Sequoyah Nuclear Plant, Units 1 and 2
Facility Operating License Nos. DPR-77 and DPR-79
NRC Docket Nos. 50-327 and 50-328

**Subject: Responses to Requests for Additional Information
Regarding 10 CFR 50.46 Annual Report**

RESPONSES TO REQUESTS FOR ADDITIONAL INFORMATION REGARDING SEQUOYAH NUCLEAR PLANT, UNITS 1 AND 2, 10 CFR 50.46 ANNUAL REPORT (NON-PROPRIETARY VERSION)

UPDATED SEQUOYAH NUCLEAR PLANT, UNITS 1 AND 2, 10 CFR 50.46 REPORT (NON-PROPRIETARY VERSION)

Figure 6-1: Carryover to Steam Generators UPTF Test 10 Run 081 Beyond 150 seconds

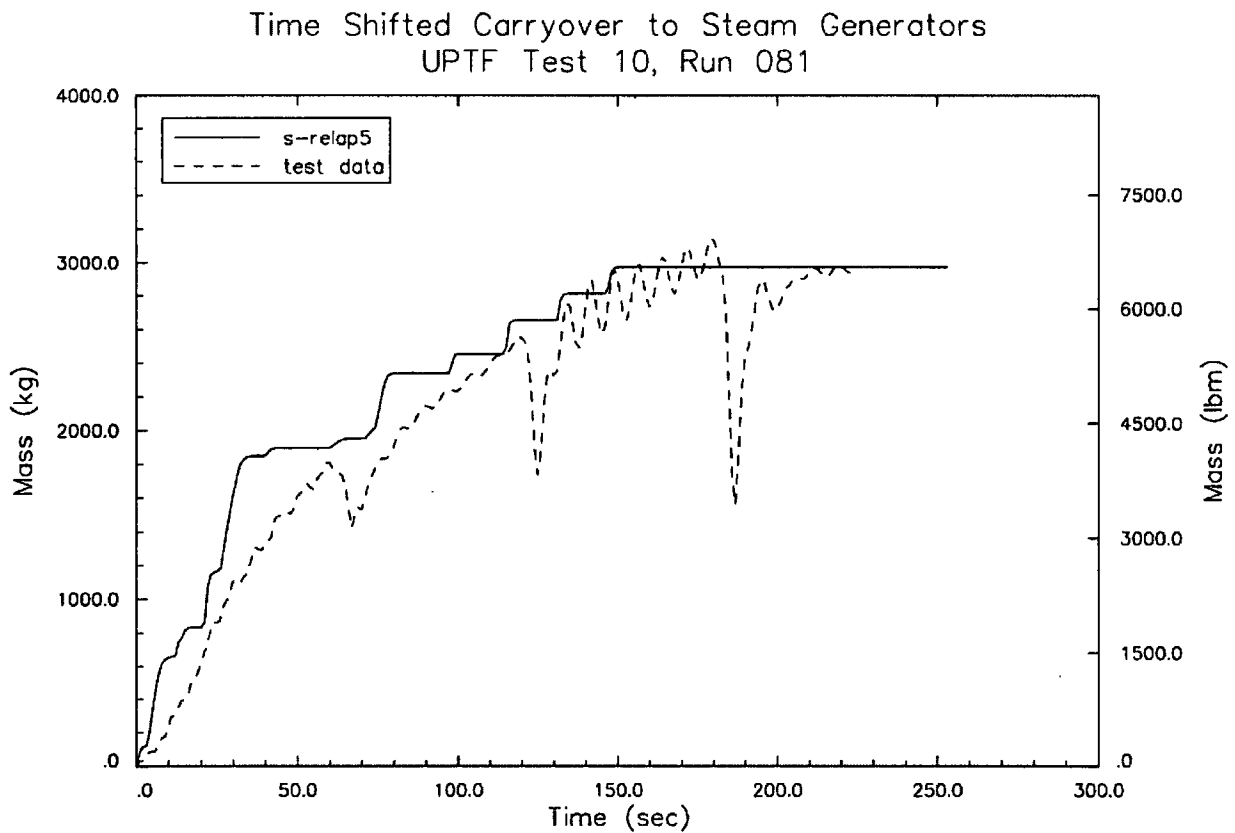
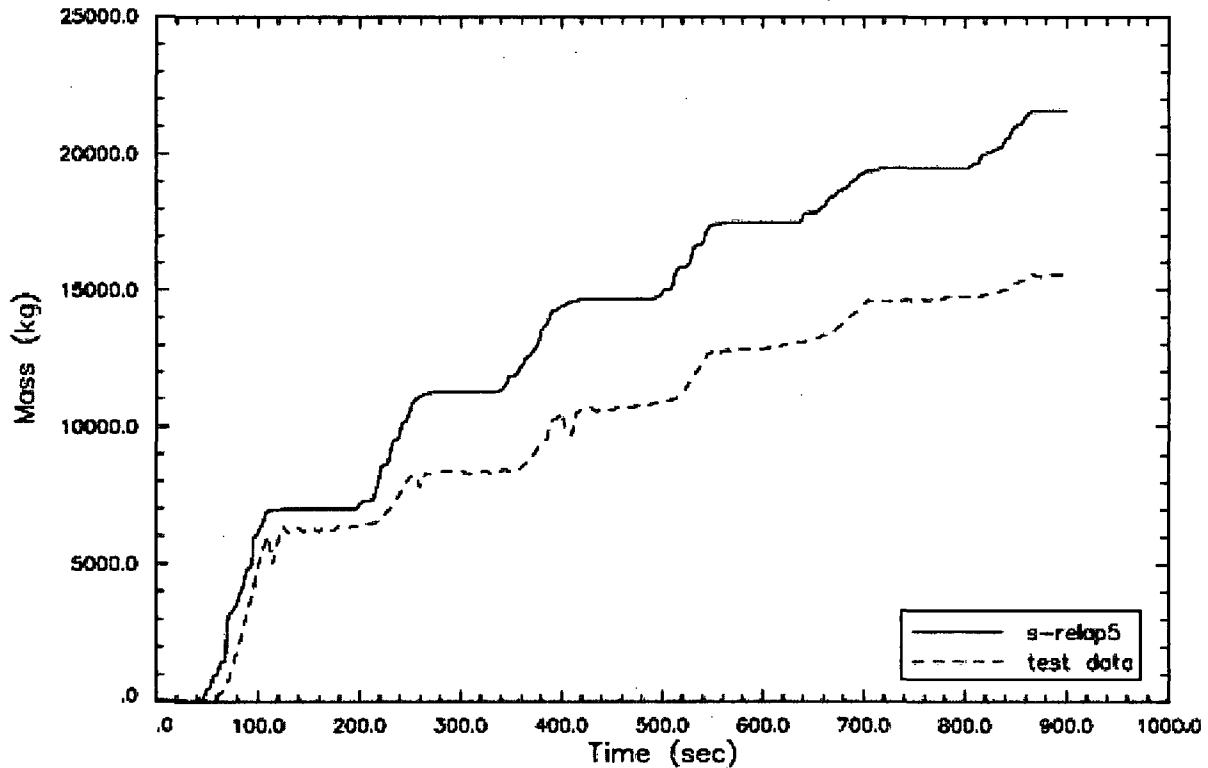
In AREVA RLBLOCA EM, FIJ was set equal to [] to perform the calculation of the carryover to the steam/water separators in UPTF Test 10B (Run 081) and Test 29B (a combination of Runs 211 and 212). Figures 2-1 and 2-2 show the measured and calculated integrated mass accumulation in the steam/water separators in Tests 10B and 29B, respectively.

Figure 6-3: Cumulative Water Carryover to Steam Generators for UPTF Test 10 Run 081

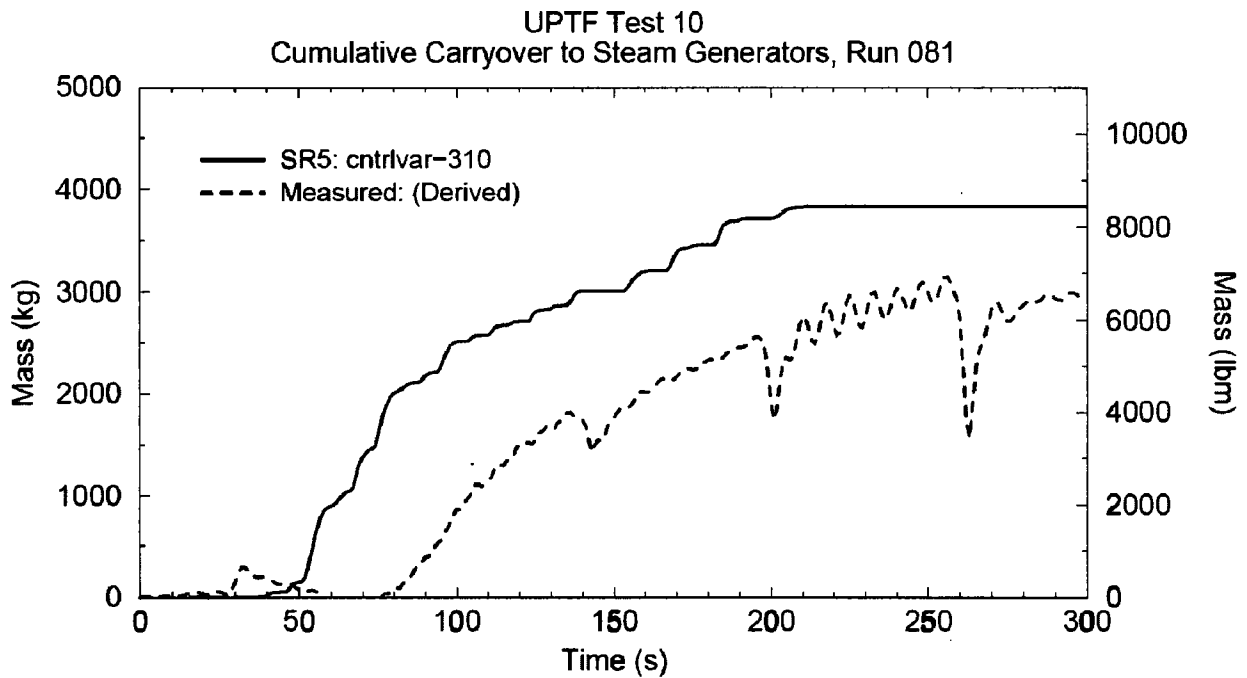
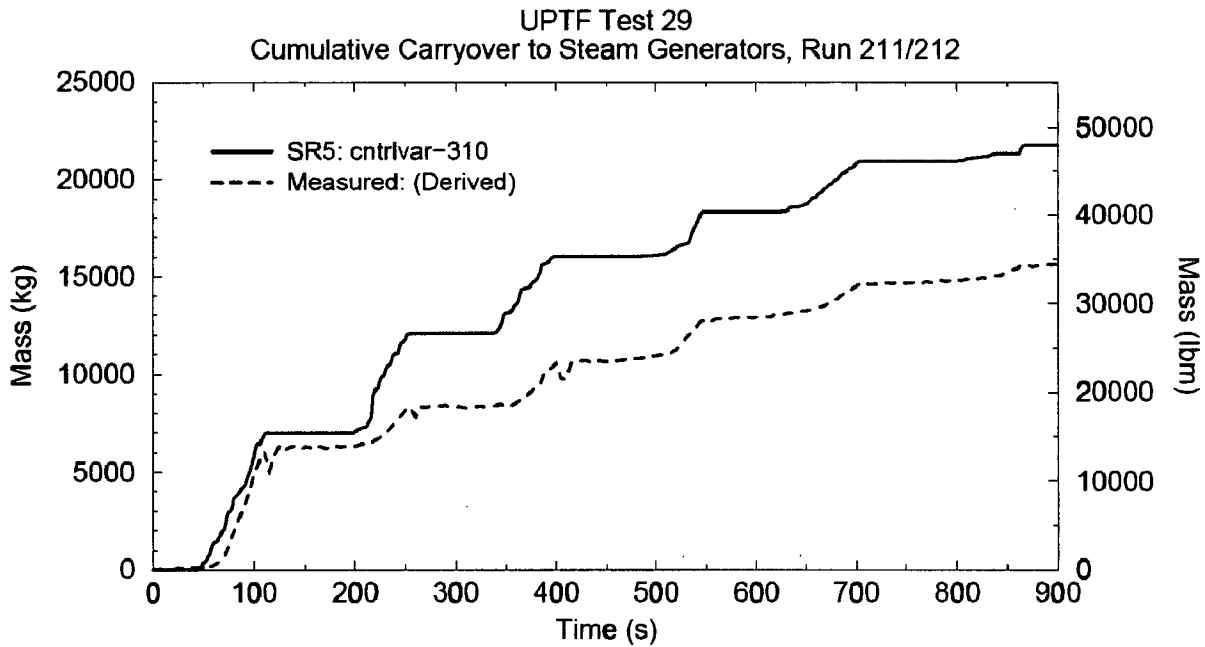
In the revised S-RELAP5 calculations of these two tests, the junction area in the entrainment calculation has been corrected and a value of FIJ equal to [] is used. Figures 2-3 and 2-4 show the measured and calculated integrated mass accumulation in the steam/water separators in Tests 10B and 29B, respectively. It can be seen that, with this change, S-RELAP5 computes a conservative amount of entrainment in simulation of these tests.

Overall, the computed liquid carryover to the steam generators is calculated in an acceptable manner when the FIJ multiplier at the tube sheet inlet is set to [].
